RCA-78-26-002-1: Install Water Shield onto Rear Zone Control Module

Document Type	Customer Satisfaction Campaign Bulletin
Date	March 4, 2026
Affected Region(s)	USA, Canada
Affected Model(s)	R1T
Model Year(s)	2023-2024
Approximate Build Dates	May 2023-April 2024
 Refer to Open Containments in ServiceOS to determine if this document applies to a specific vehicle.	
Vehicle System	78 - Low Voltage Electrical

7. Install:

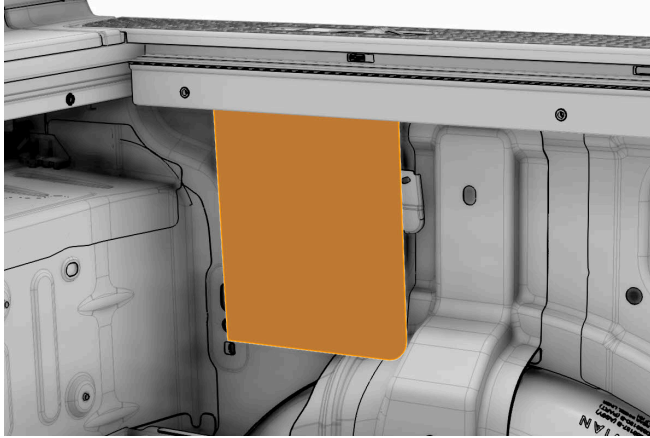
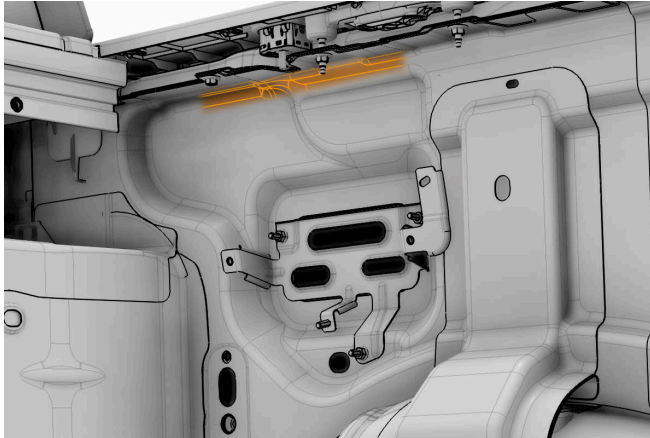
- a. Position the component(s) as shown.

- b. Attach the butyl strip on the component to the highlighted area.
